AGENDA
MONTGOMERY TOWNSHIP
BOARD OF SUPERVISORS
DECEMBER 16, 2019

Future Public Hearings/Meetings:

Please be advised that we have reviewed the Preliminary/Final Land Development Plans for Montgomery Realty Associates, LLC prepared by Bohler Engineering dated October 29, 2018, last revised September 23, 2019.

Picture No .1

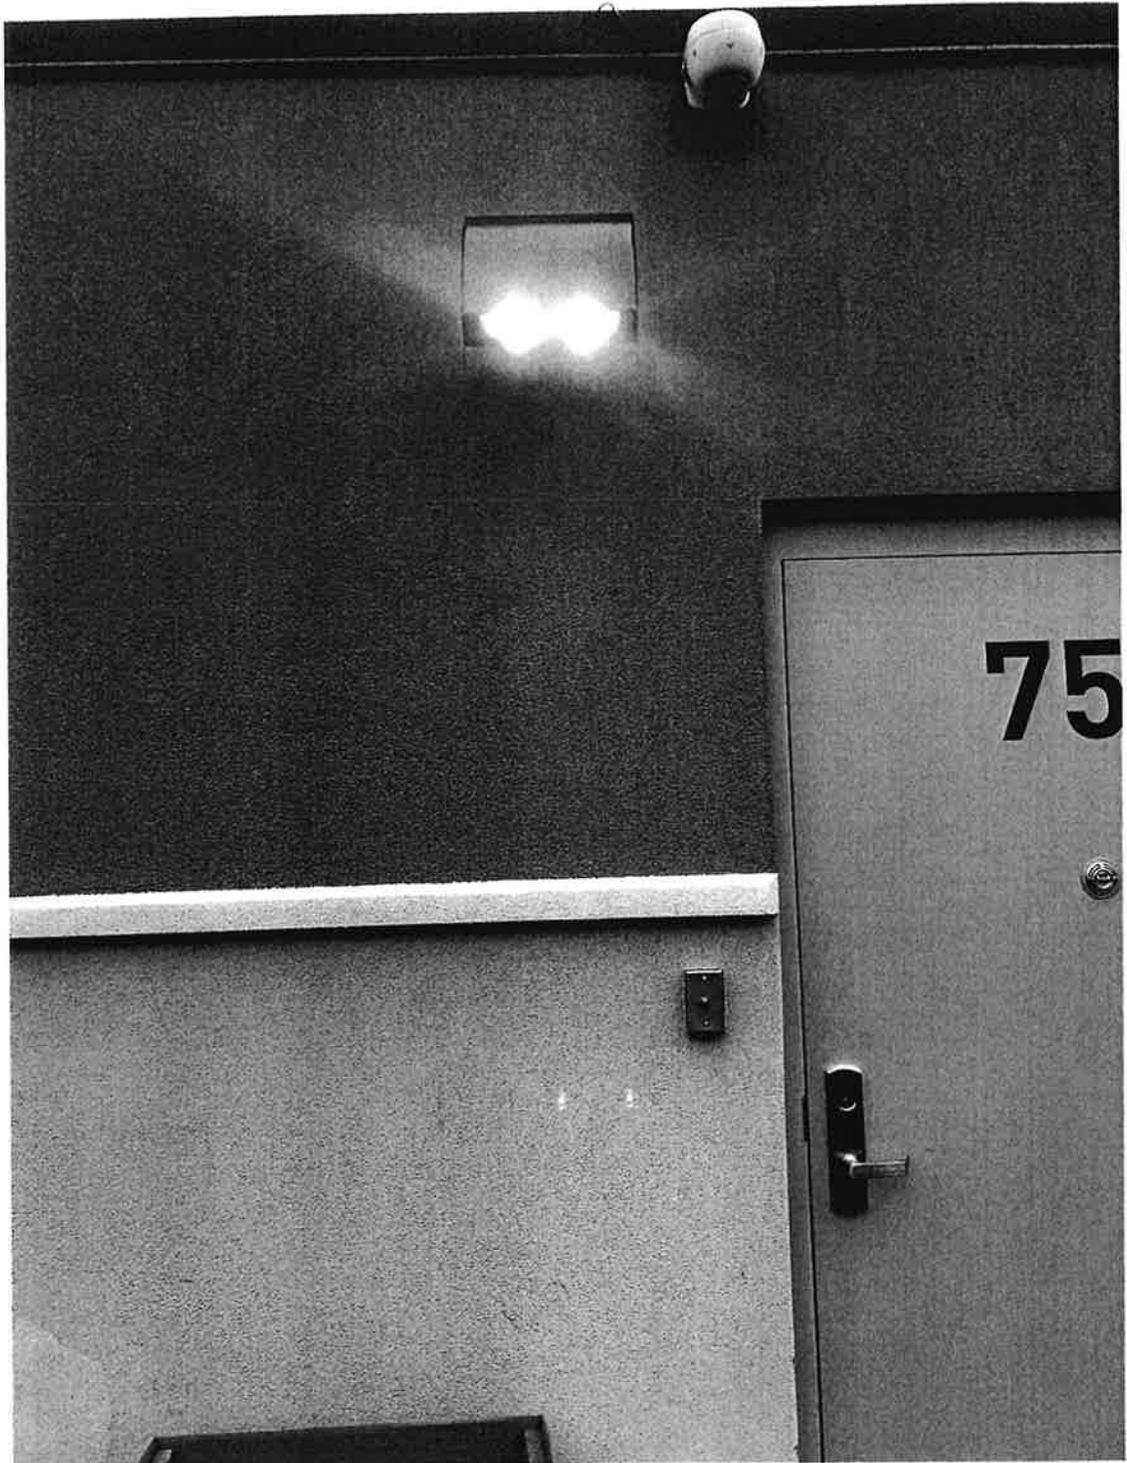
- See Picture Nos. 1 and 3 enclosed with this letter.
- Site Lights were observed to be on and operating after normal hours of operation at 1:00 AM.
 - This operation does not comply with lighting note #5, on the latest approved plan sheet LL-101.

- Advertising signs and building signs were observed to be on and operating after normal hours of operation at 1:00 AM.
 - This operation does not comply with lighting note #6, on the latest approved plan sheet LL-101.
